**SB-18-010 COE RELAY BLOCK (VACUUM RELAY
CORROSION)**

**GROUP: 27-ELECTRICAL SYSTEMS
BULLETIN NO: SB-18-010
DATE: 4-16-2018
REFERENCE: HMM-170707-J1**

SUBJECT VEHICLES: 13MY-17MY Cab Over Engine (COE) Trucks equipped with a J05 engine.

Mounting Position Has Changed

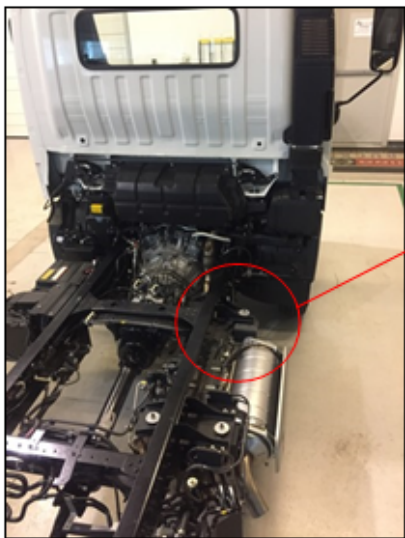
To enhance the waterproof performance of the relay block, the mounting position has been changed and the vent in the relay block cover has been removed.

Relay Cover Vent Removed
